NYBERG RIVERS

Response to City of Tualatin Letter

Addendum #1 to the Master Plan submitted March 19, 2013

RE: Review Comments: Nyberg Rivers Master Plan (MP-13-01)

Exhibit A

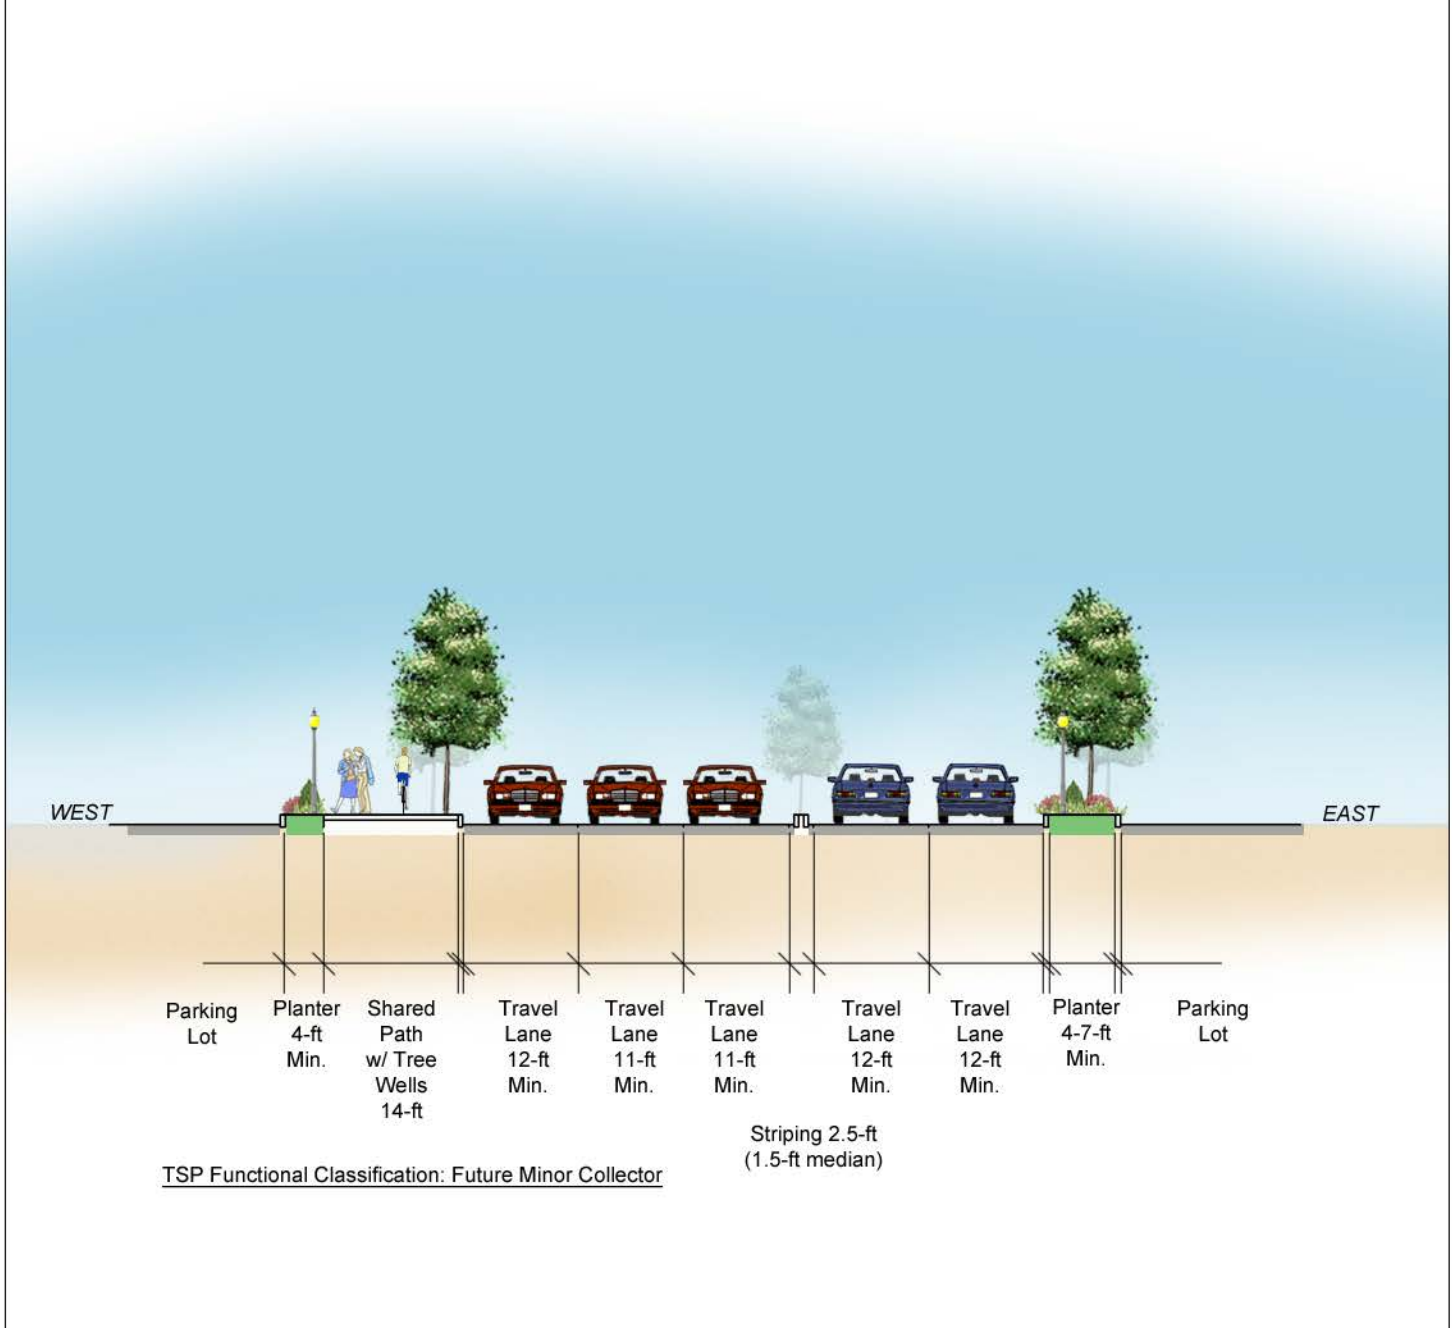
3. *The Central Urban Renewal Plan requires that Master Plan applications represent the entire block. The applicant met this requirement by showing “Future Development” areas on Blocks 4 and 5 however the entirety of Block 2 is not show in the Master Plan Boundary. Please revise the Development Plan to include the entire Block 2 in the Master Plan Boundary.*

6. *On Page 7 of the Master Plan, under "Proposed Uses", the applicant states that drive-through service windows will be retained for Buildings, A, B, C and E. Please clarify. Bldg. B does not currently have a drive-through use.*

Additionally, the plan sheets are inconsistent throughout the document. For example, Cross Section B-B shows a 12 foot multiuse path on the north side but in a later drawing it is shown to be only 10 feet wide. As mentioned above, no portion of this sidewalk in this cross-section and subsequent plans should be less than 12 feet in width.

The Development Plan has been revised to include the entirety of Block 2, as requested. The updated Nyberg Rivers Master Plan document has been updated to reflect this request. The Site Plan, attached as Exhibit A, dated 6/17/2013, does show the entirety of Block 2.

Building B does not currently have a drive-through. This error on the plans has been corrected and the master plan document has been edited to remove the reference. The attached Site Plan, Exhibit A, dated 6/17/2013 reflects these updates.

The plan sheets have been corrected and show a path width of 11 to 12 feet, with variation provided for tree wells. The updated Site Plan, attached as Exhibit A and dated 6/17/2013, does show these paths.

Exhibit B

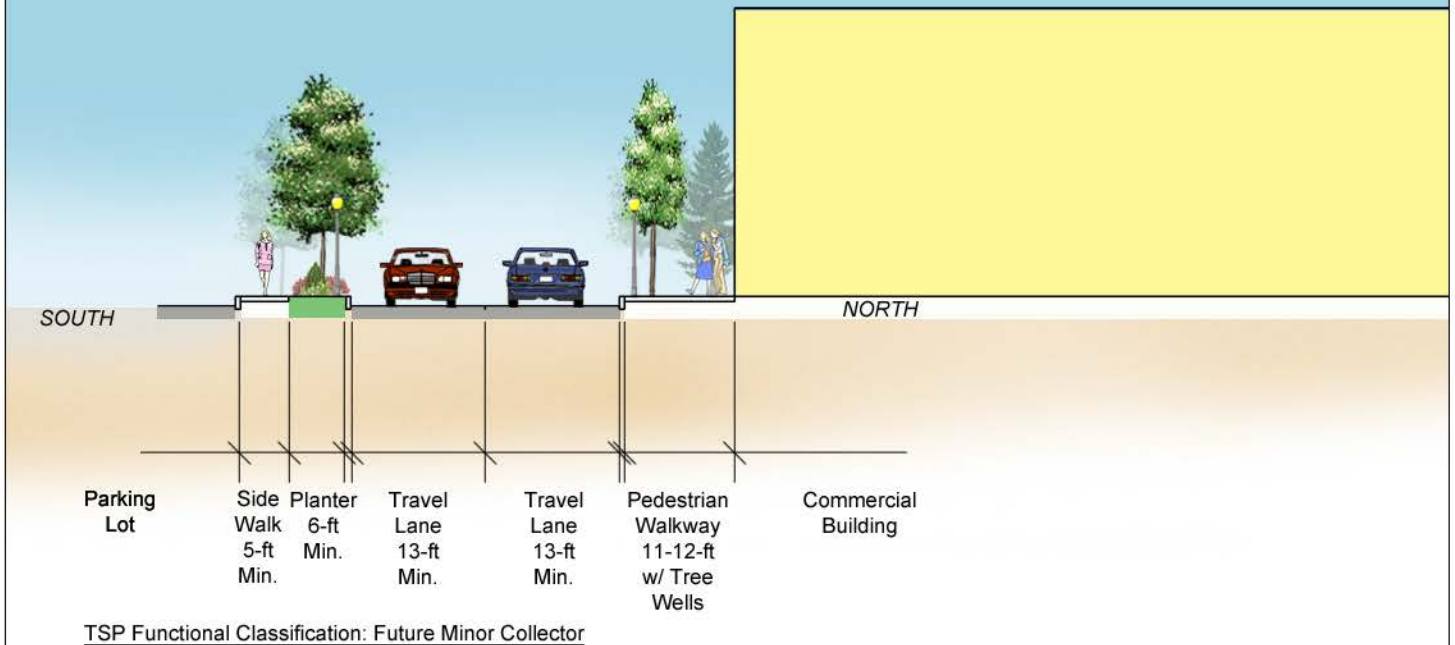
- **Cross-section A-A: Nyberg Entrance**
 - A 4 to 7-foot planter strip on the east side with curb, streetlights, and trees. The City requested a 6-foot planter strip.

- (1) 5-foot sidewalk on the south side. The City requested a 6-foot sidewalk.
- **Exhibit B: Cross-section A-A:**
 - A 4 to 7-foot planter strip on the east side with curb, streetlights, and trees. The City requested a 6-foot planter strip.
 - A 4-foot planter with curb, streetlights, and groundcover and shrubs. Allowed by the City with the provision of the 14-foot path with tree wells
 - A 14-foot shared path with tree wells
 - (3) southbound travel lanes. (1) 12-foot southbound travel lane and (2) 11-foot southbound travel lanes for a total of 34-feet. The City requested (3) 12-foot travel lanes for a total of 36-feet.
 - (2) northbound 12-foot travel lanes
 - A center median consisting of an 18-inch concrete median, with striping on both sides for a total of 2.5-feet. The cross-section does show a width for the median.

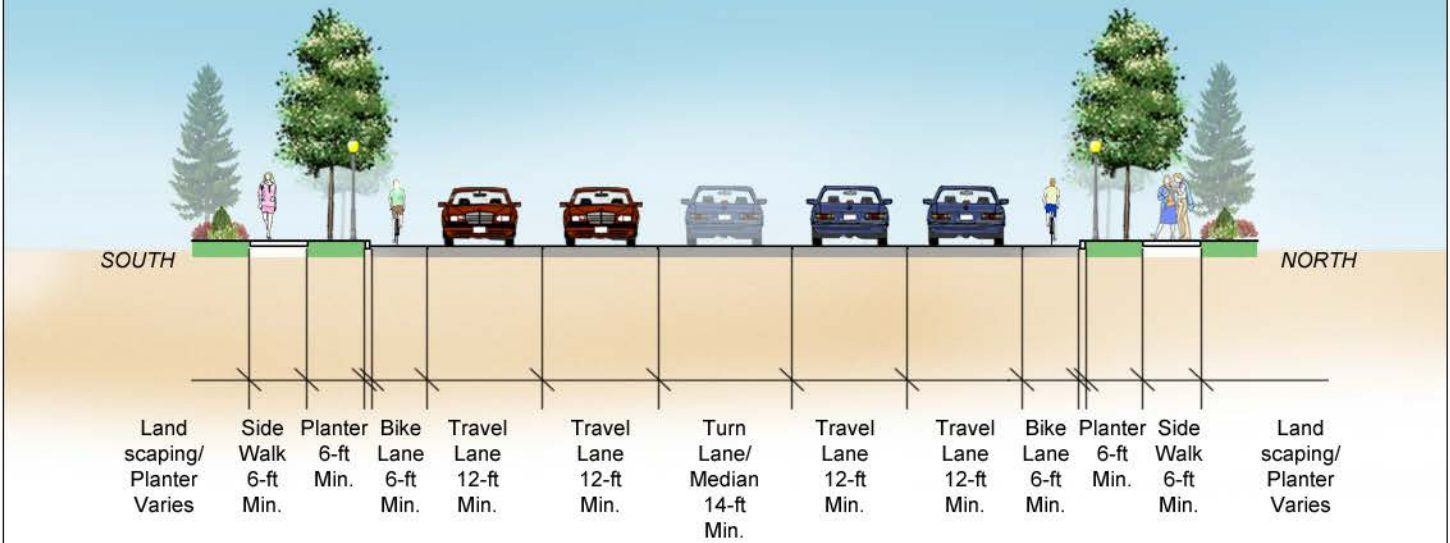
- **Exhibit E: Street “A”:**
 - Shown on cross section **D-D**
 - A 12-foot multi-use path on the west side
 - A 4-foot planter strip with curb, streetlights, and trees.

Street “A”: Cross-section D-D attached as Exhibit E and dated 6/11/2013 contains each of the City’s comments and the applicant’s response.

Exhibit H

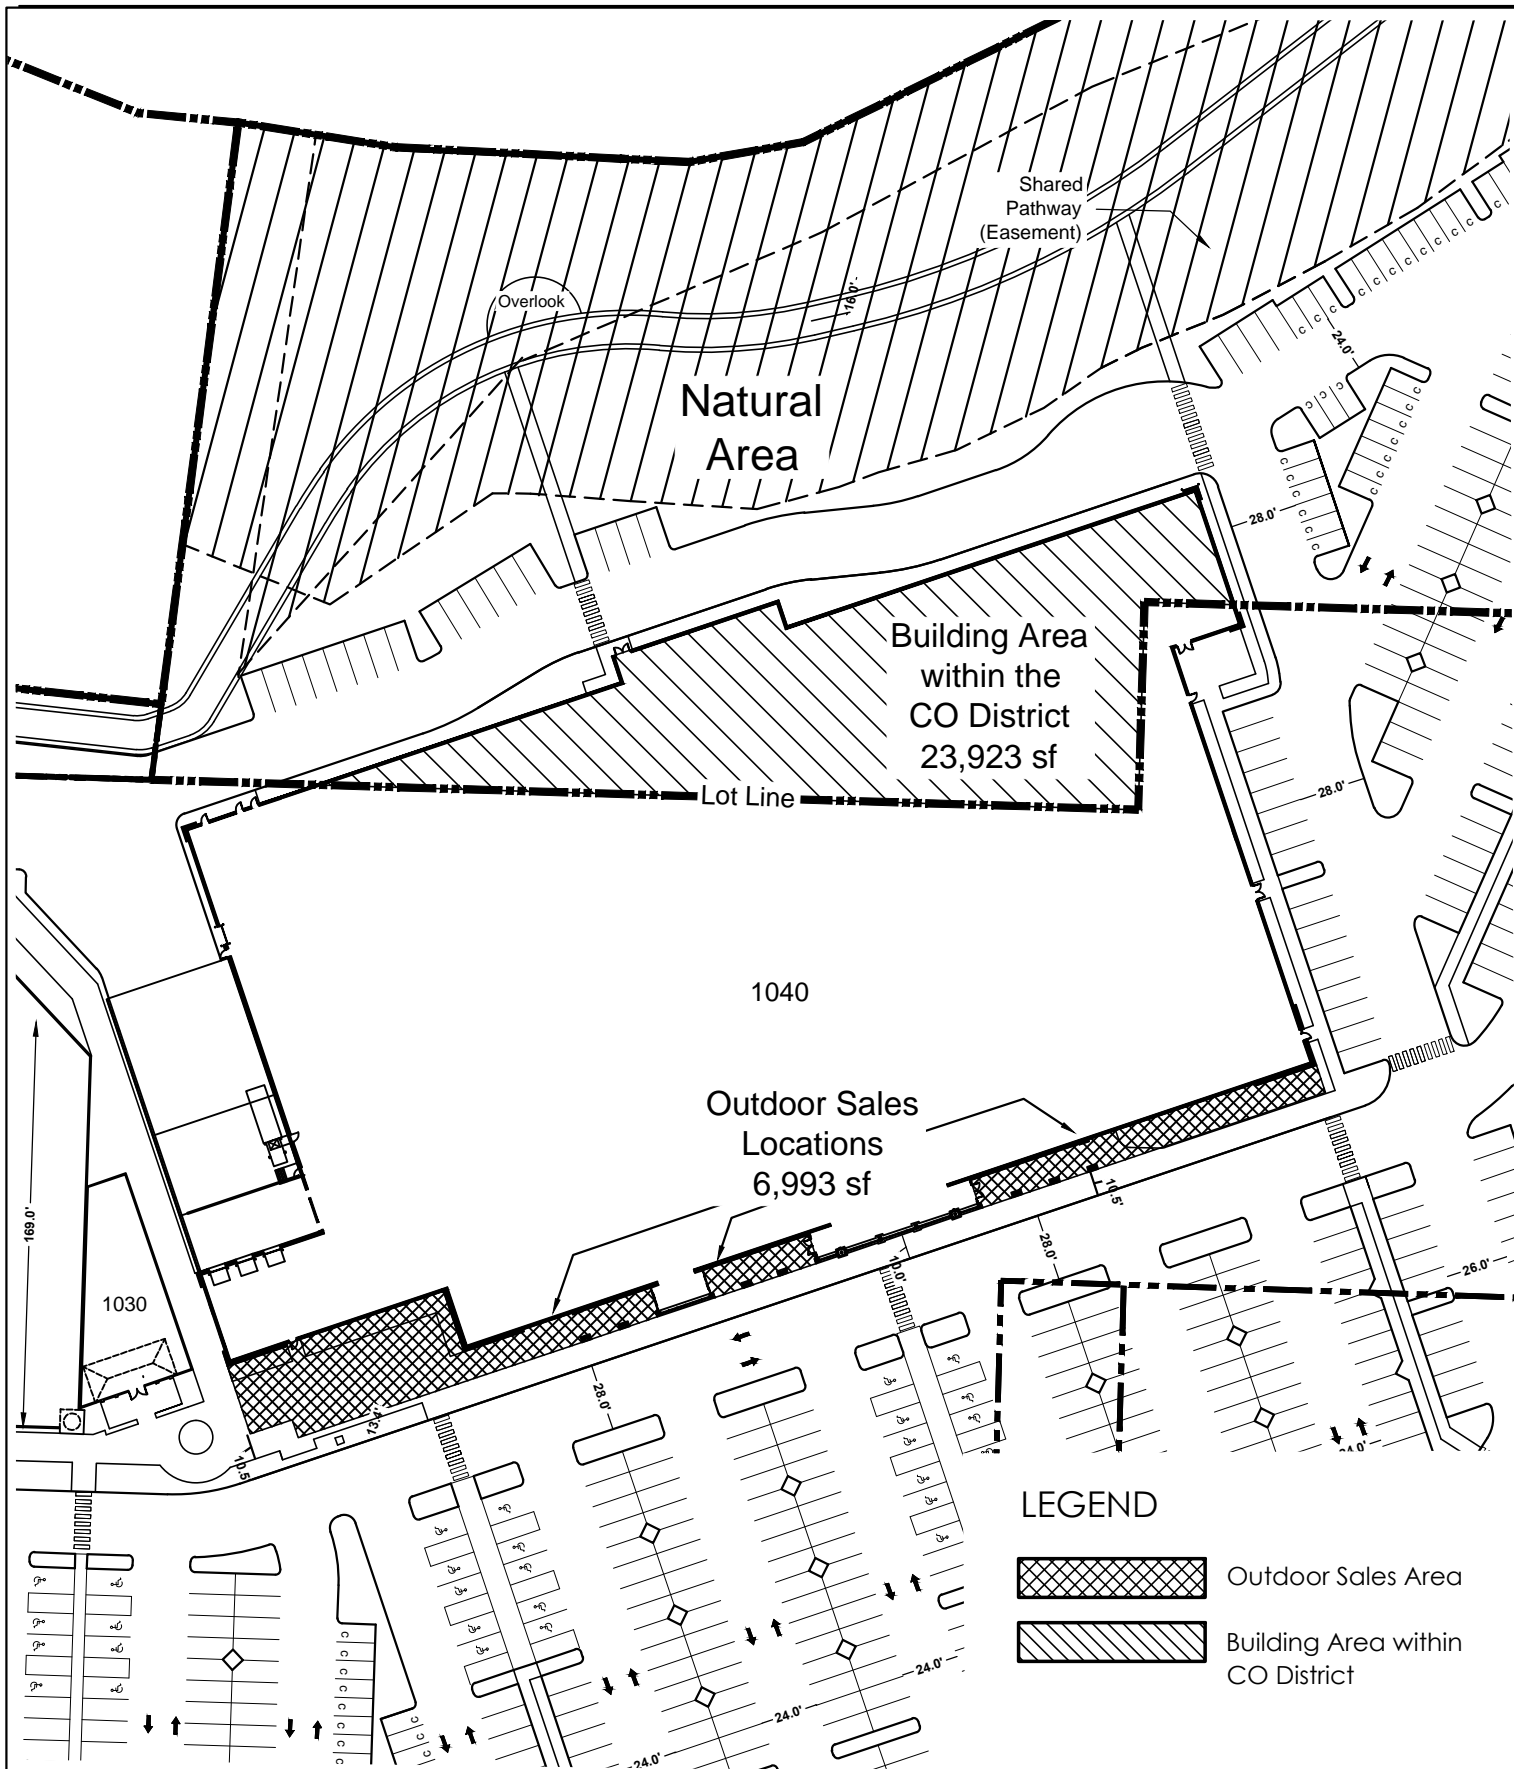
- **Nyberg Street between the entrance of the site and I-5: cross-section G-G**
 - The applicant is proposing a 4-foot planter strip with curb, streetlights, and trees. With direction received from ODOT (who has jurisdiction over this section of roadway), the City has requested a 6-foot planter.

- **Exhibit H: Nyberg Street between the entrance of the site and I-5:**
 - Shown on cross section G-G
 - 6-foot sidewalk on the north side of Nyberg Road
 - The applicant is proposing a 4-foot planter strip with curb, streetlights, and trees, which differs from the City request for a 6-foot planter.
 - A 15-foot westbound right-turn lane, which is greater than the requested 12-foot lane.
 - A 6-foot bike lane
 - No proposed changes to the existing west and east-bound turn lanes
